## WATER INGRESS AT REAR OF VEHICLE

### TECHNICAL SERVICE BULLETIN

Reference Number(s): 76/01/03/NAS,Â Date of Issue:Â January 17, 2003

LAND ROVER: Discovery Series II (LT)

**Fig. 1: Applying Sealant Between Roof & Rear Header Outer Joint**

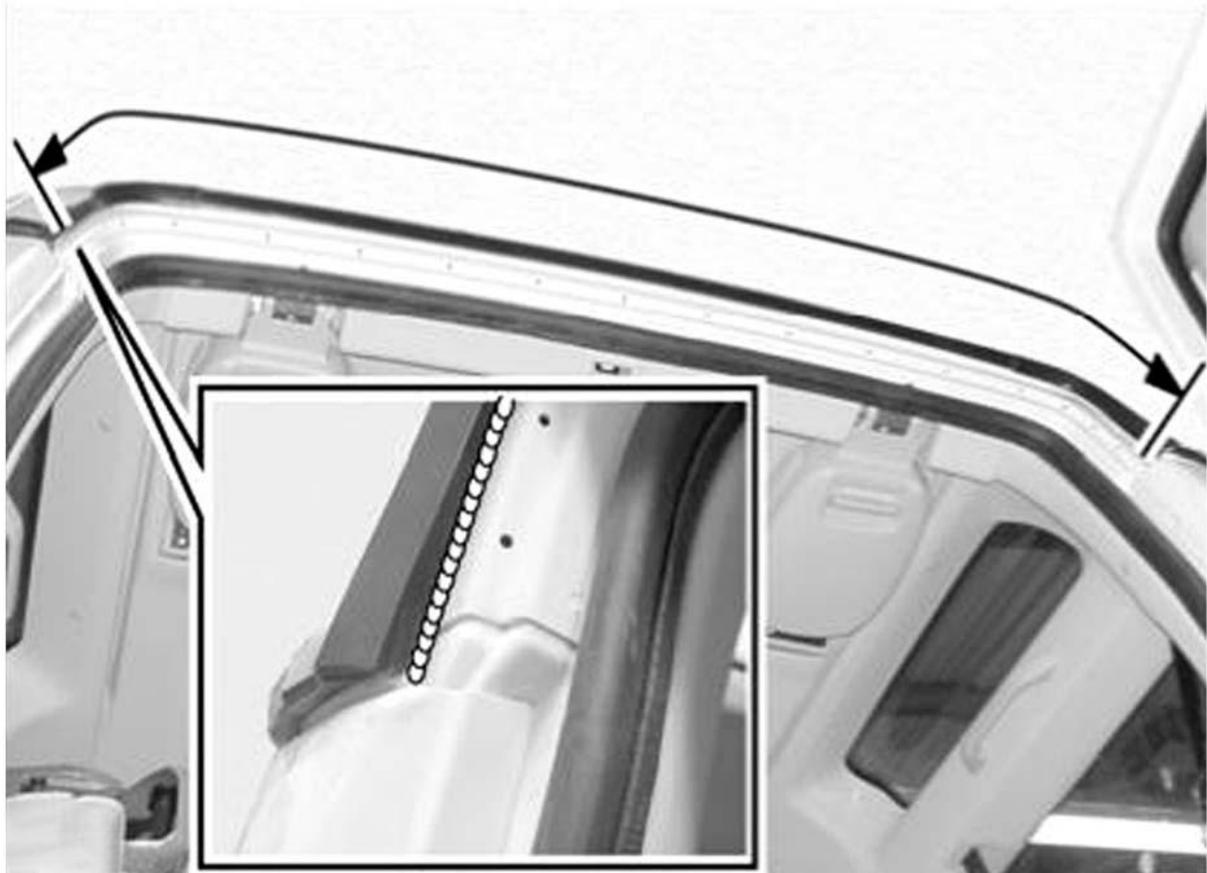
A sealing operation between the roof and the rear header outer joint may have been inadvertently omitted during production. The lack of sealant in the joint can permit water ingress.

Where a complaint of water ingress is confirmed and the cause is determined to be insufficient sealant in the body seam, follow the rectification procedure in this TIB to apply sealant between the roof and rear header outer joint.

1. Open the tail door.
2. Release 17 clips securing the tail door opening secondary seal to the body.

3. Remove the seal.
4. Clean between the roof and the rear header outer joint ([Fig. 1](#)).
5. Apply a continuous bead of sealant between the roof and the rear header outer joint (Inset in [Fig. 1](#)).

6. Wipe off any excess sealant.
7. Fit and secure the tail door opening secondary seal to the body.
8. Close the tail door.
